ACCESSION NBR:8010220501 DOC.DATE: 80/10/17 NOTARIZED: NO
 FACIL:50-335 St. Lucie Plant, Unit 1, Florida Power & Light Co.
 AUTH.NAME AUTHOR AFFILIATION
 UHRIG,R.E. Florida Power & Light Co.
 RECIP.NAME RECIPIENT AFFILIATION
 NOVAK,T.M. Assistant Director for Operating Reactors

SUBJECT: Forwards stress analysis of drain & fill method for cooling reactor & responses to NRC 800708 ltr re potential effects of rapid RCS depressurization.No excessive stress levels occurred during normal cooldown.

October 17, 1980
L-80-343

RE: St. Lucie Unit 1
Docket No. 50-335
Natural Circulation Cooldown

Figure 1

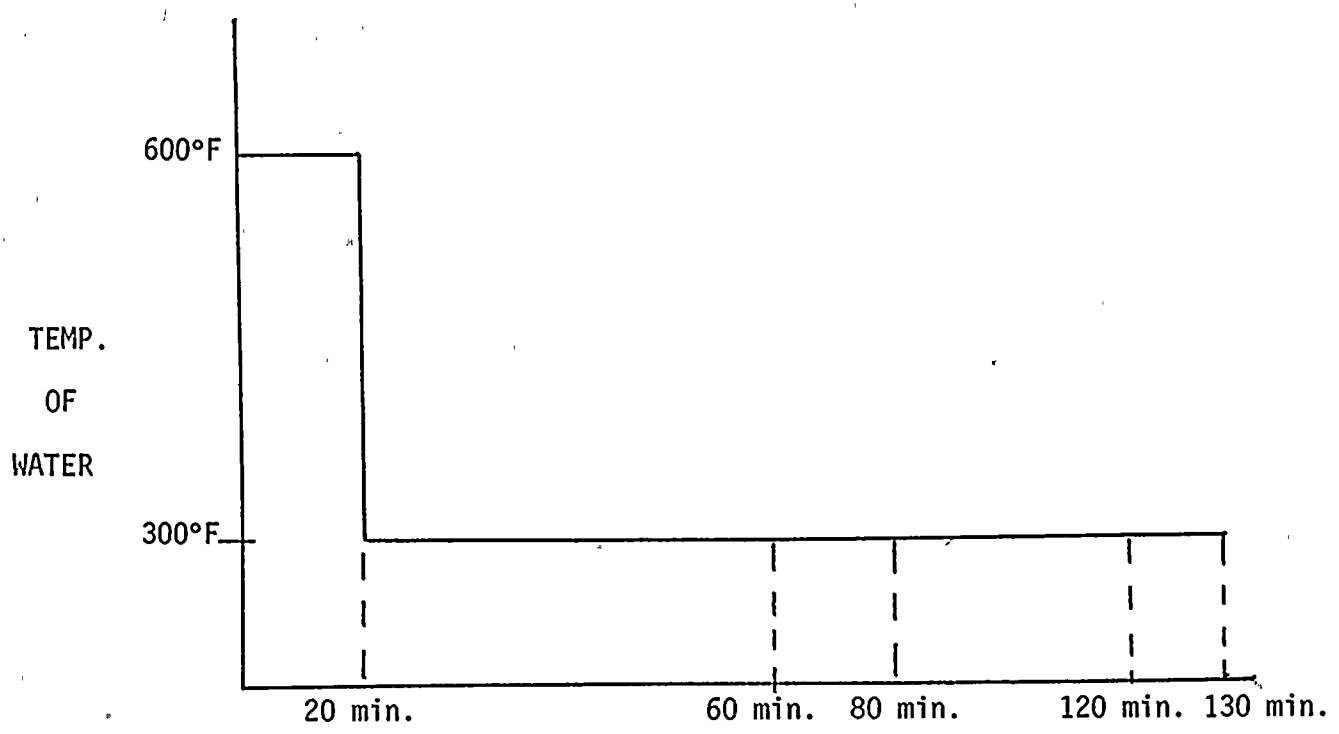
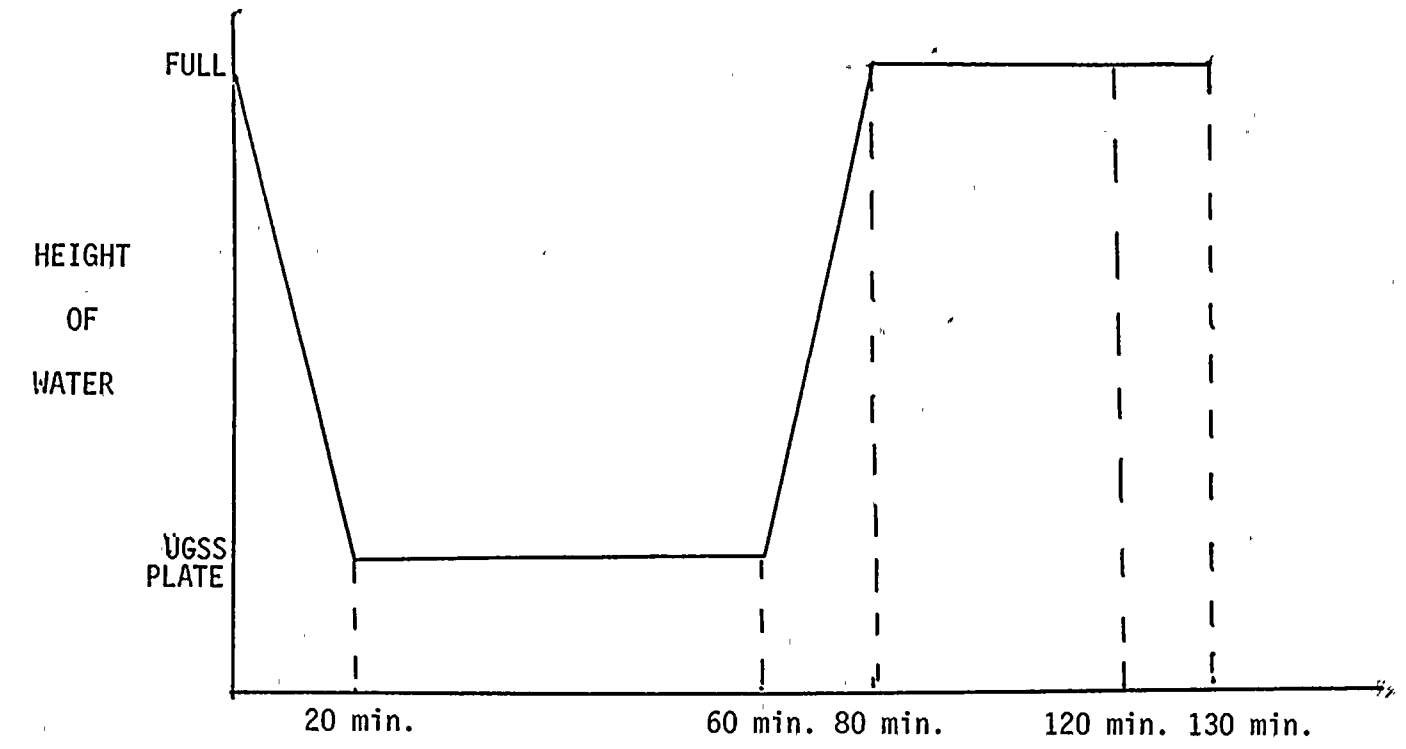
A combined thermal/stress analysis was performed to determine the range of stresses produced in the reactor vessel head due to voiding of the upper head region. In performing the thermal analysis, "worst case" assumptions were made in defining the fluid temperature and initial vessel temperatures. The assumptions which define the thermal transient are as follows and illustrated on Figure 1.

1. The upper head is drained down to the upper guide support structure plate in 20 minutes with both fluid and metal temperatures remaining at 600°F.
2. The water level is held at this height for 40 minutes with a fluid temperature of 300°F.
3. The head is refilled over a 20 minute period with 300°F water.
4. The upper head remains filled with 300° water for a period of time.
5. The heat transfer coefficient for the water is large ($H=500 \text{ Btu/ft}^2 \text{ - hr-}^\circ\text{F}$).
6. The heat transfer coefficient for steam is very small ($H=0. \text{ Btu/ft}^2\text{-hr-}^\circ\text{F}$).

Temperatures calculated for this transient were applied to a stress analysis model. The results of this analysis indicate that the highest stresses occur in the "knuckle" region of the head near the inside radius. The magnitude of stresses produced for this transient were found to be no more severe than the stresses occurring during a normal cooldown of 100°F/hr.
